WCS Proj #: Boxford-26A

RE: Supplemental Information, NOI Application, Culvert Replacement, 49 Woodcrest Road, Boxford, MA (DEP File # 114-1203)

Photo B. View of the downslope side of the culvert at 49 Woodcrest Road in mid-spring 2015. Photo by B. Prokop.

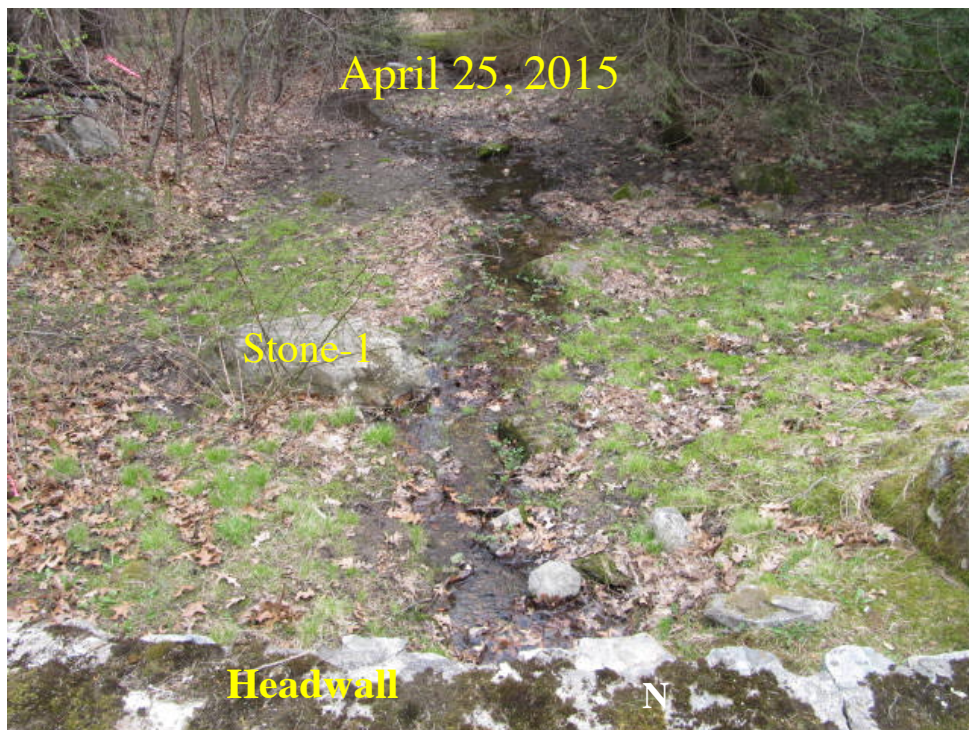
Flow on the outlet side of the culvert is somewhat dispersed and only partially contained within a channel. If any Bank exists, the Bank is only 2" to 3" high (see Photos A and B). Photo B shows water flow within a shallow channel in early Spring that subsequently disperses after a short distance.
